CITY OF DETROIT
 DEPARTMENT OF PUBLIC WORKS
 CITY ENGINEERS OFFICE
 STREET DESIGN

PAVING PLAN AND PROFILES FOR
 HARRY SLATKIN SUBDIVISION NO. 4
 ARCHER (SEE REDFERN FOR ORIGINAL)

SHEET OF SHEETS
 CONTRACT NO. *P.W. 3296 W*
 DRWG NO. *C-293*
 DATE SEPT. 4, 1957

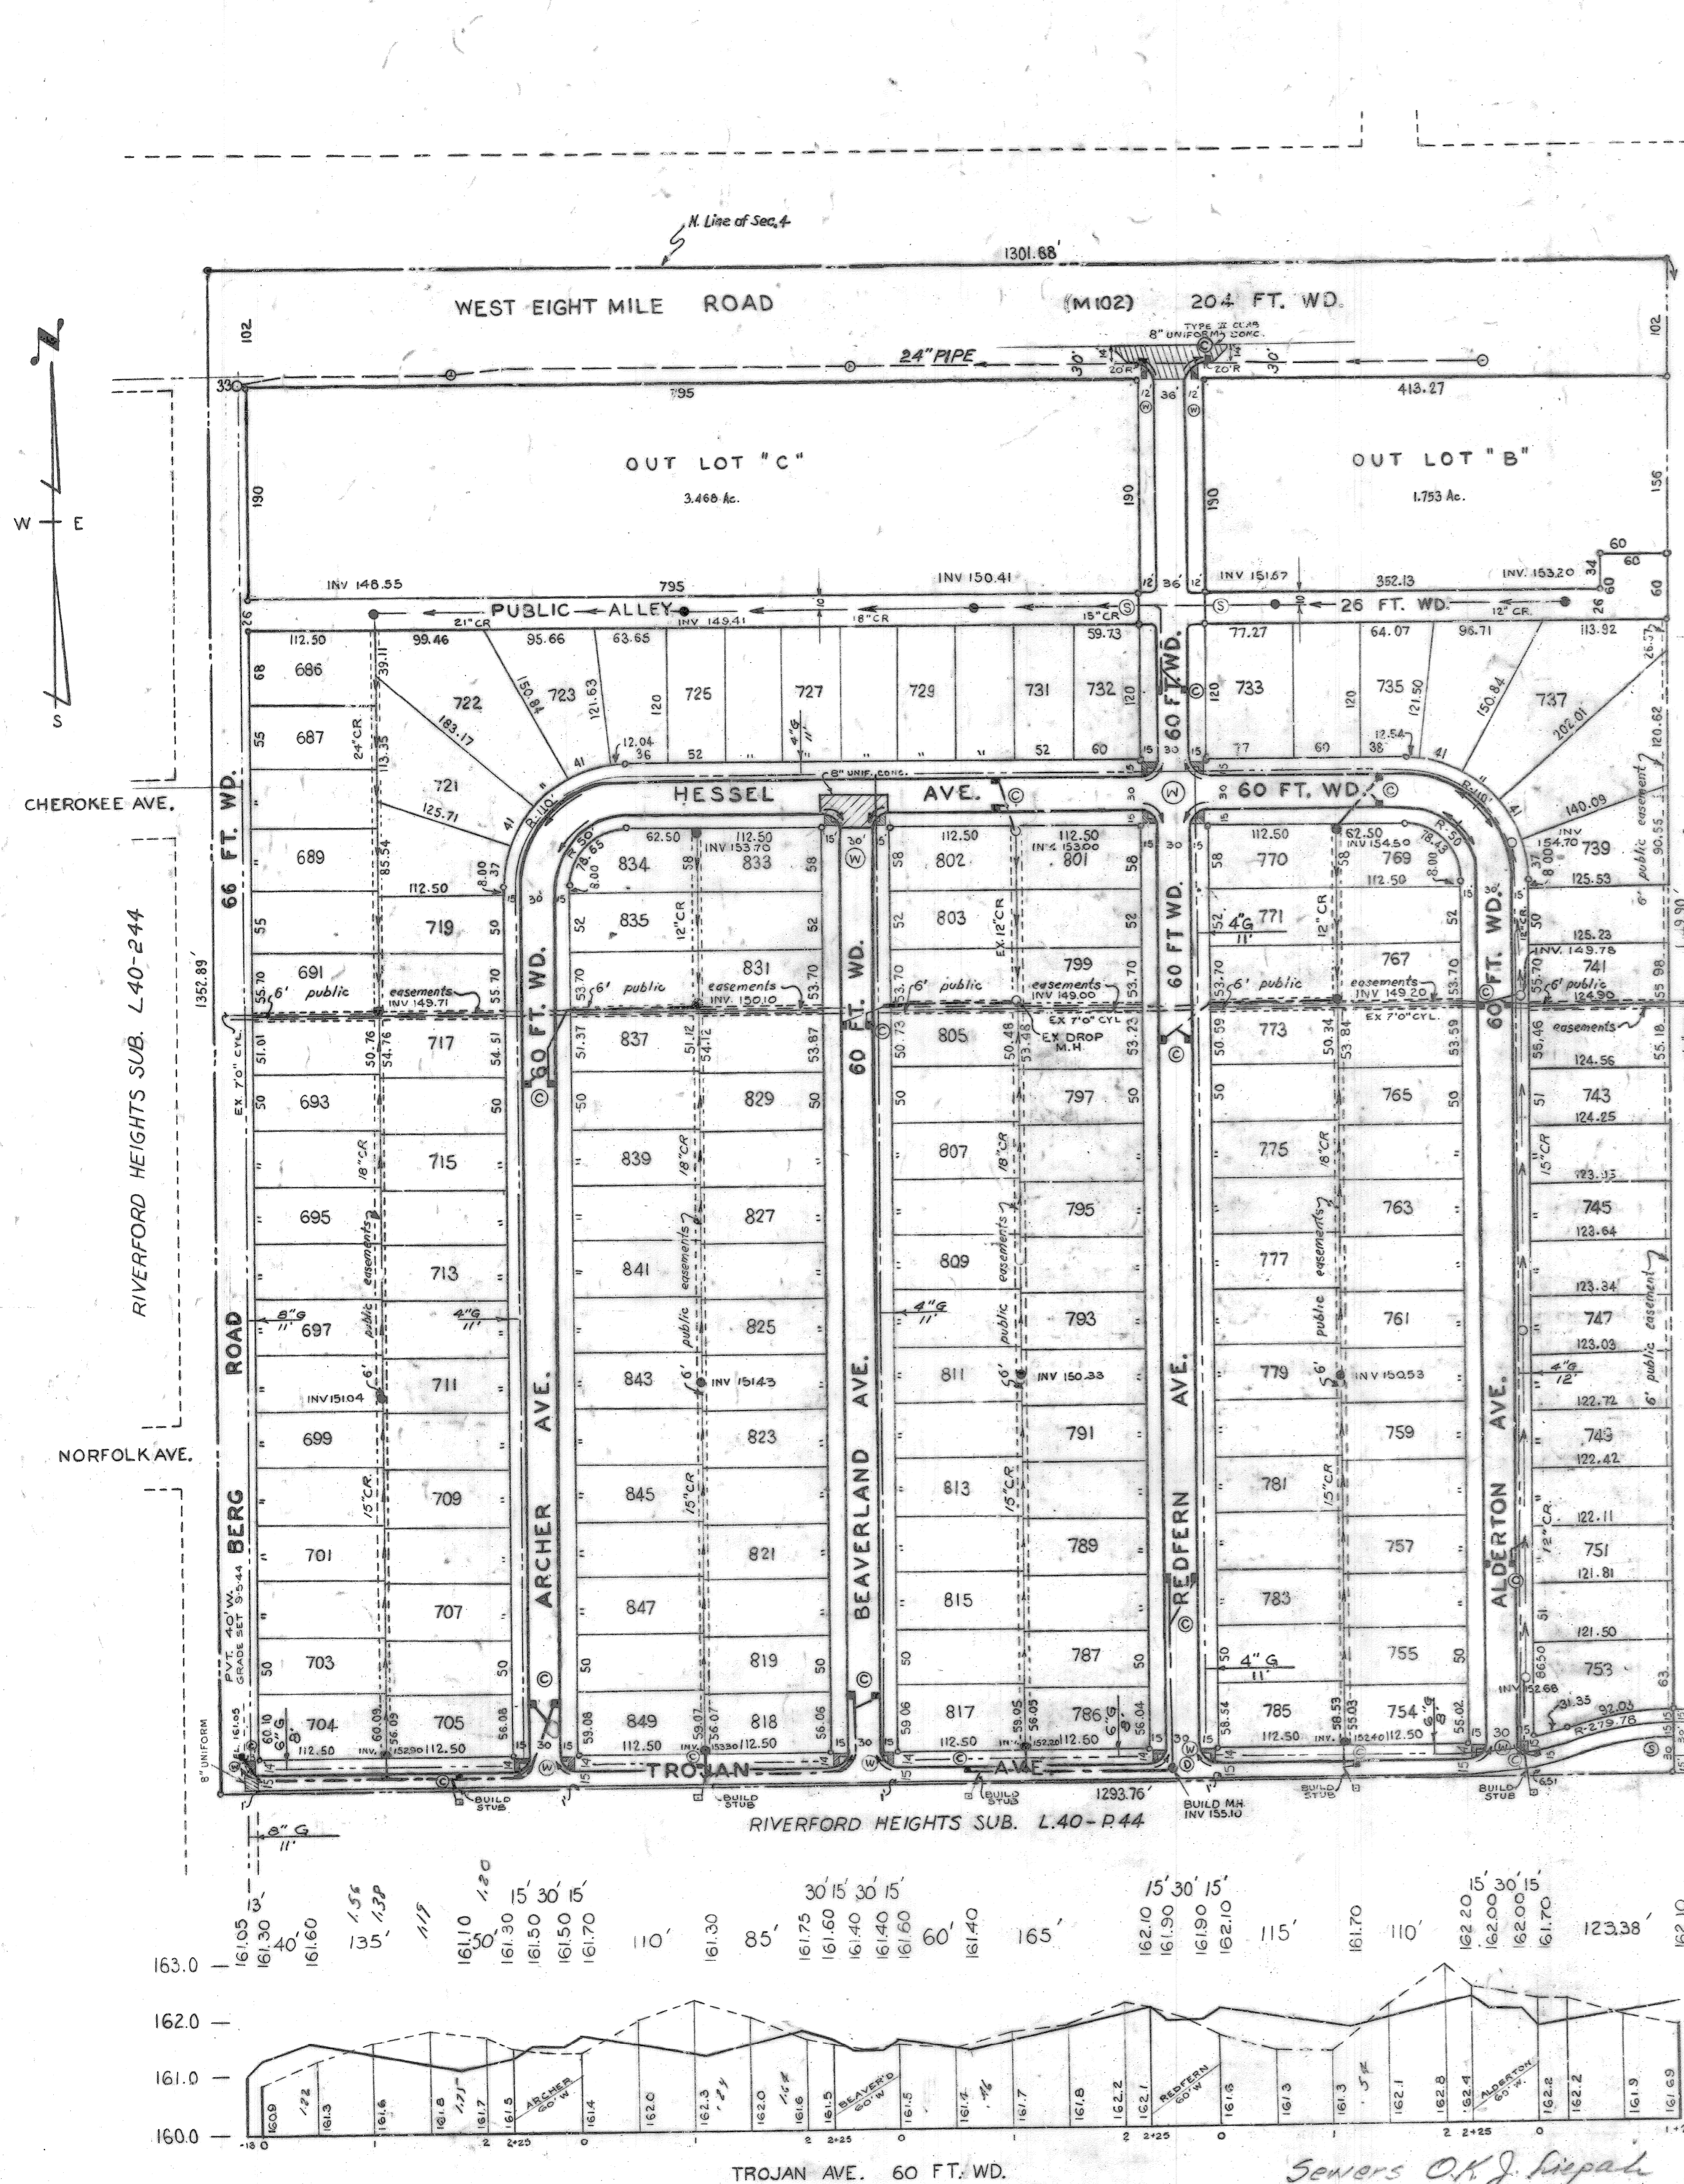
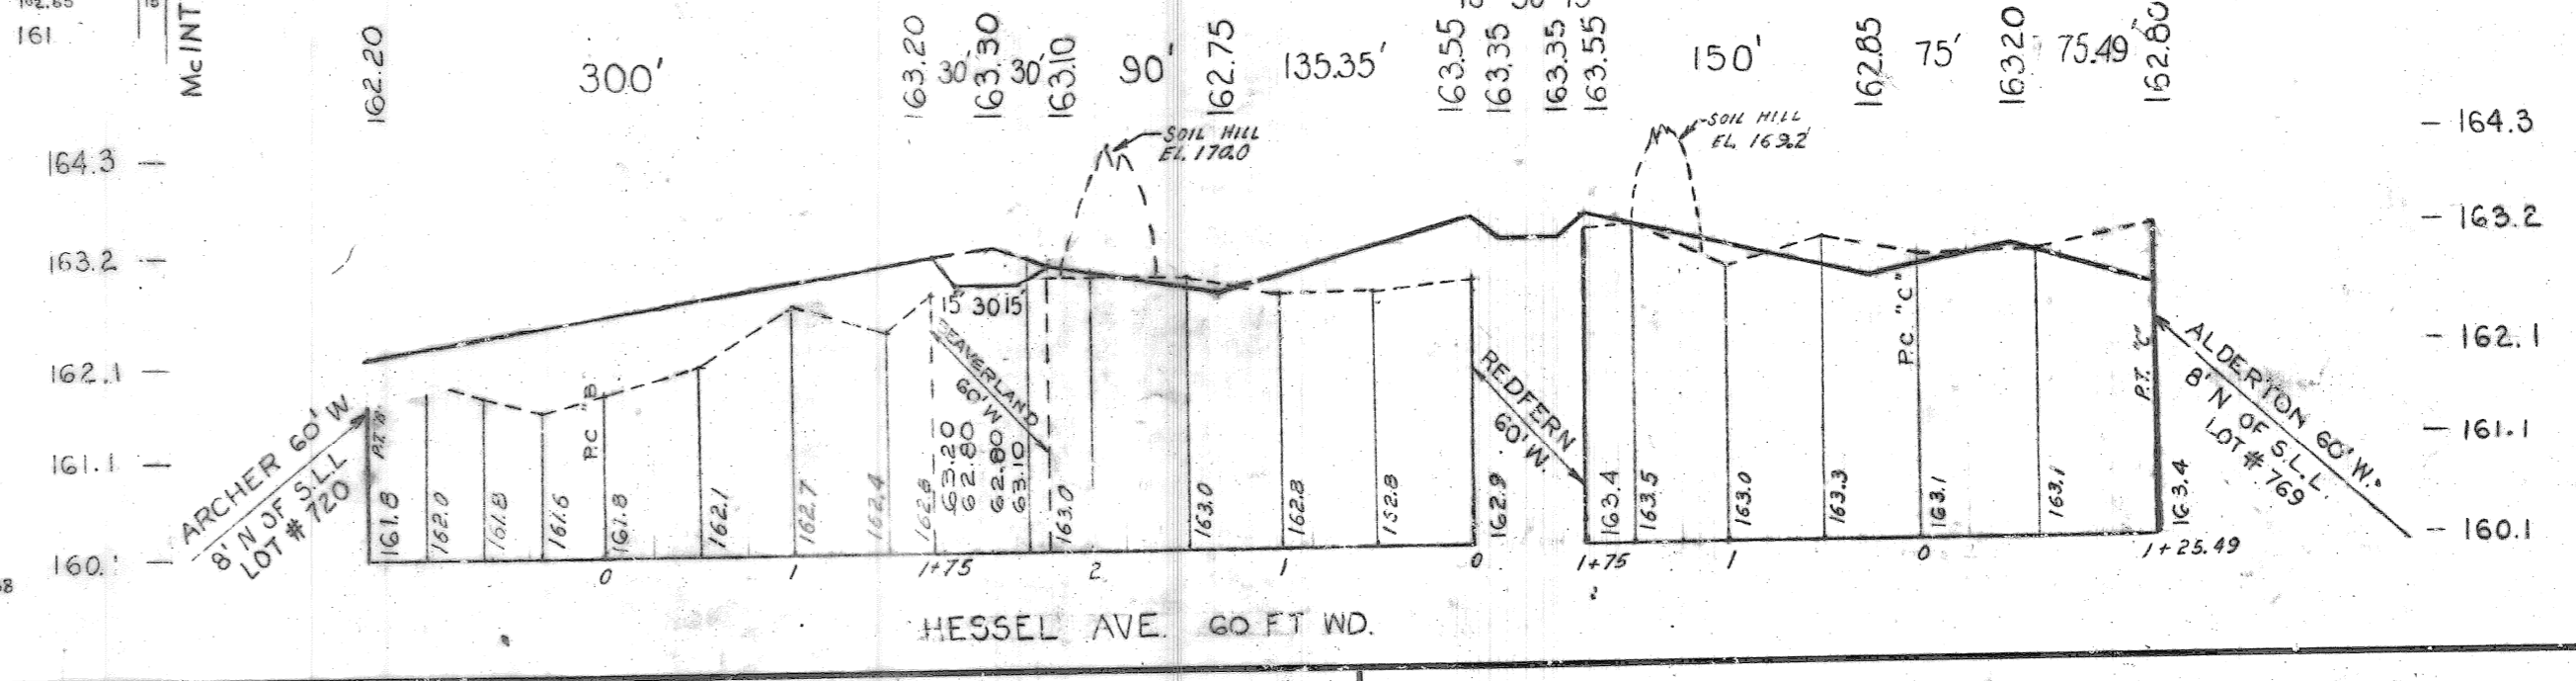
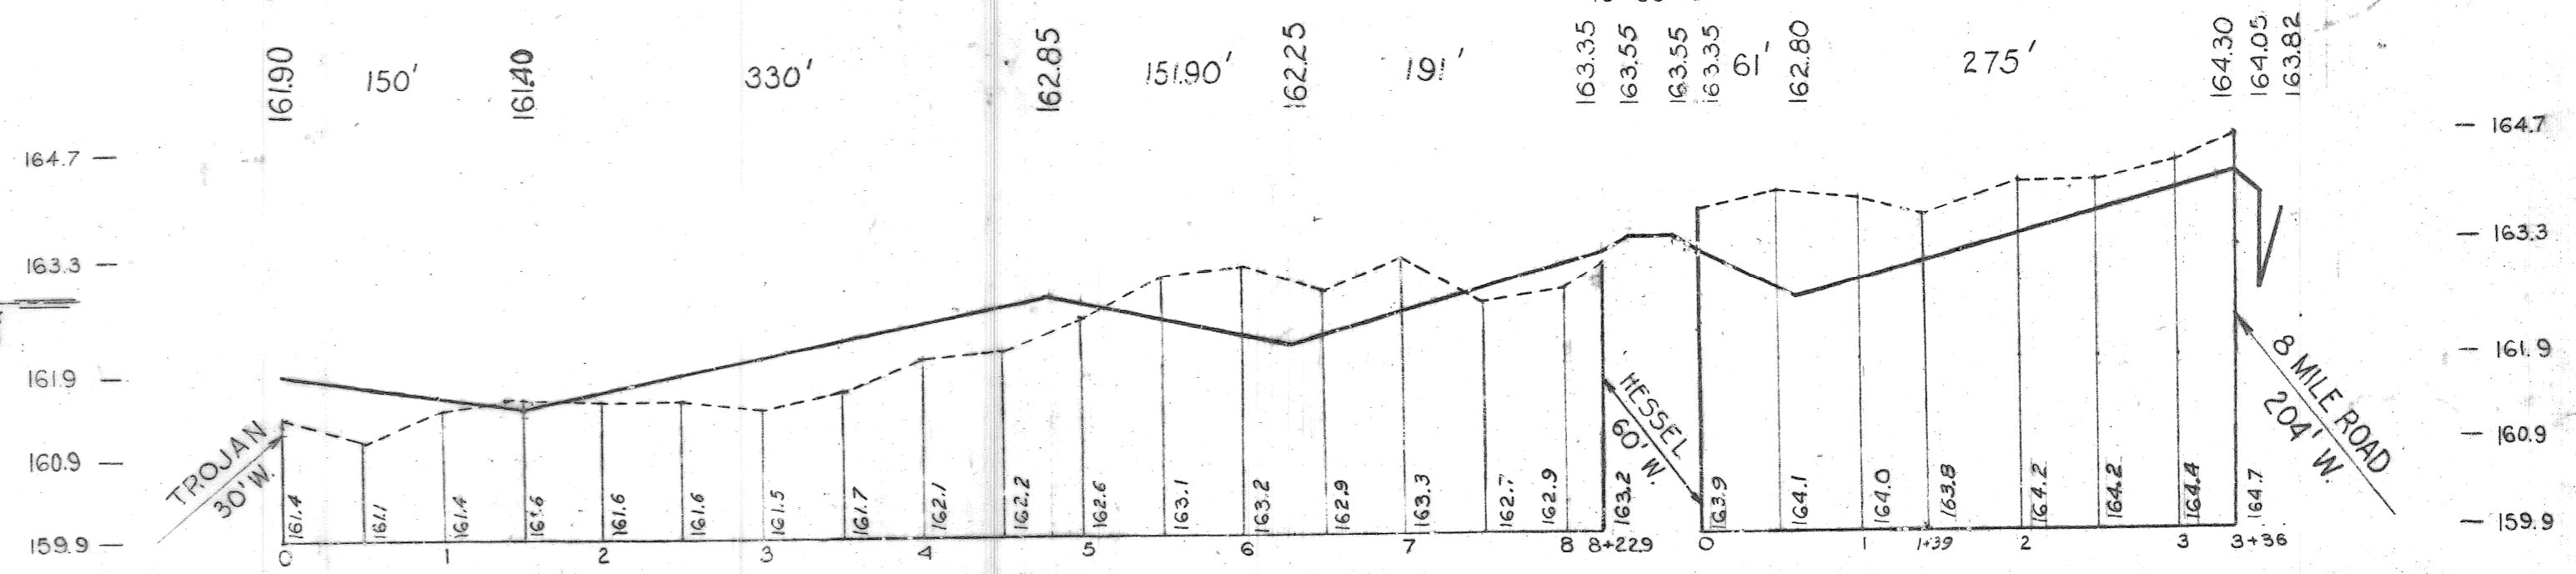
GRADE CHANGED ON ARCHER FROM STA. 0+45 - 7+74.22
 GRADE CHANGED ON HESSEL FROM STA. 0+00 - 3+30.00
 OCTOBER 6, 1957
 S. JONES

NO.	DESCRIPTION	DATE	BY	CHKD.	APVD.
1	GRADE CHANGED ON ARCHER STA 0+45 - 7+74.22	10-6-57	S. JONES	J.E.	
2	GRADE CHANGED ON HESSEL STA 0+00 - 3+30.00	10-6-57	S. JONES	J.E.	
3	QUANTITIES ADDED	11-1-57	S. JONES	J.E.	
4	GAS MAIN ADDED	11-1-57	S. JONES	J.E.	
5	GAS LINES ADDED	11-1-57	S. JONES	J.E.
